ALERT SERVICE BULLETIN

ASB248

RESTRICTED OPERATION, LIFE LIMIT AND REPETITIVE BLADE AIRFOIL INSPECTION REQUIREMENTS

3A32C406/82NDB-X and D3A32C409/82NDB-X

Figure 1. Blade Surface Repair (Sheet 1)

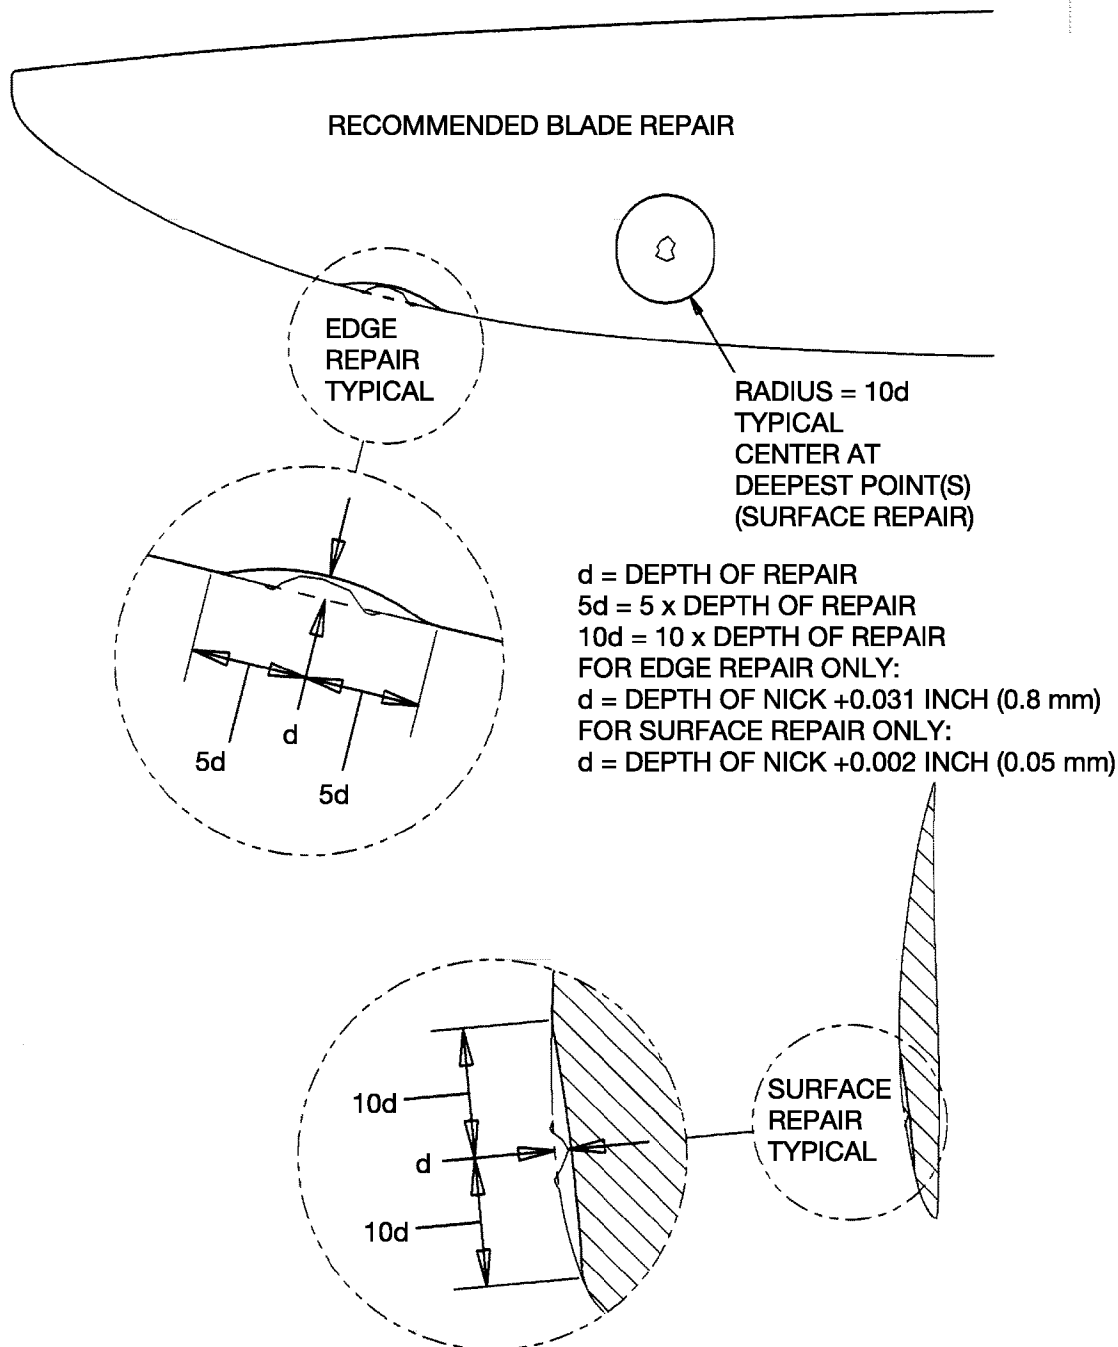
- (a) Repair stress riser damage by filing the damaged area as illustrated in Figure 1.
- (b) Do not perform additional repairs on the blade after the stress riser has been removed. Unnecessary repairs will cause premature replacement of blades at overhaul.
- (c) If damage exceeds 1/8 inch depth on the leading edge or 1/16 inch depth on the face or camber side, the propeller must be sent to a propeller repair facility for repair.

- (a) Remove metal at the damaged area starting back from and working toward the edge in such a way that the contour remains substantially the same.
 - 1 File strokes must run from blade shank to blade tip.
 - 2 Avoid abrupt changes in contour and blunt edges.
- (b) (Refer to Figure 1.) Blend the area to a length of 10 times the depth of the nick.
- (c) Work the repair surface to a smooth finish with fine grain emery cloth, crocus cloth, or 600 grit sandpaper.

- (a) Remove metal at damaged area using a hand held rotary grinder with a sanding bob with 120 grit or less, or by hand using coarse grain emery cloth. Do not use a file in this area.
- (b) (Refer to Figure 1.) Grind the blade with light pressure in a circular motion until the damage is totally removed.
 - 1 The repaired area must have a diameter equal to 20 times the depth of the damage as illustrated in Figure 1.

Figure 2. Blade Life Limit Stamping (Sheet 1)

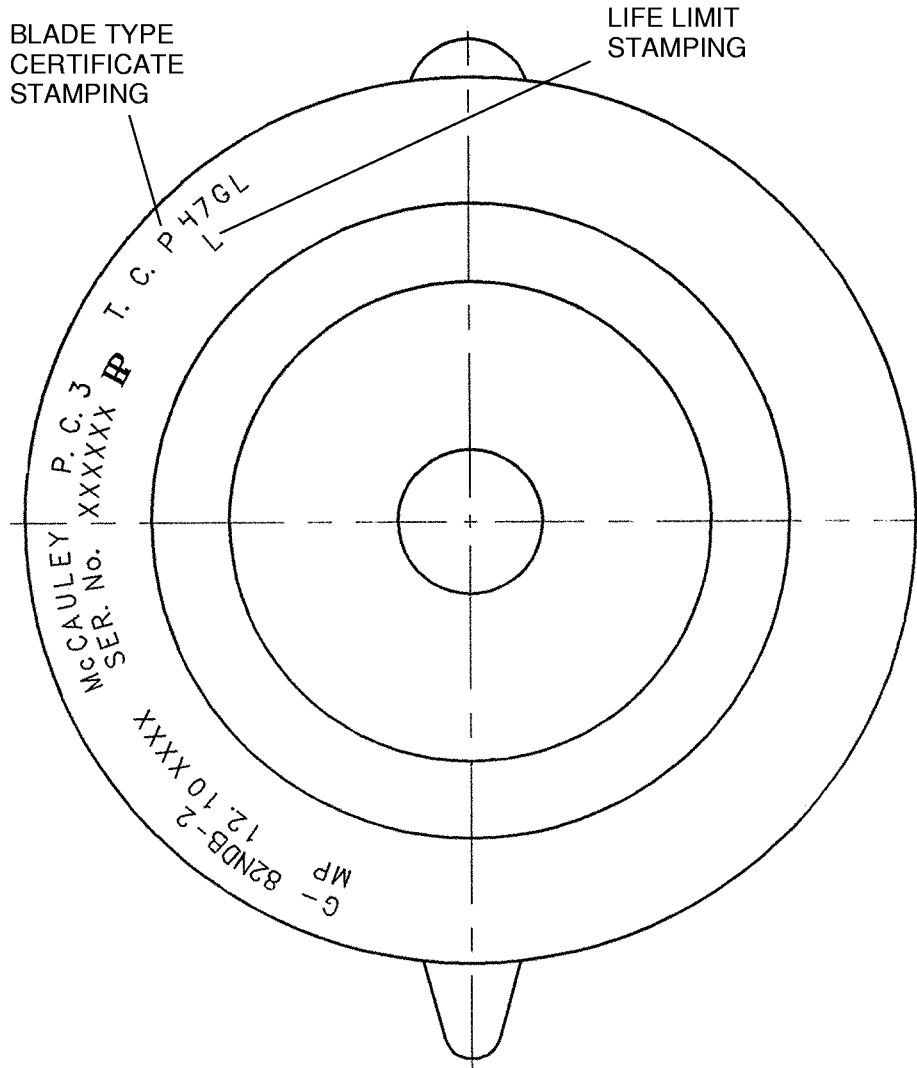
(1) (Refer to Figure 2.) The life limit stamping "L" must be stamped under the blade type certificate stamping on each blade.
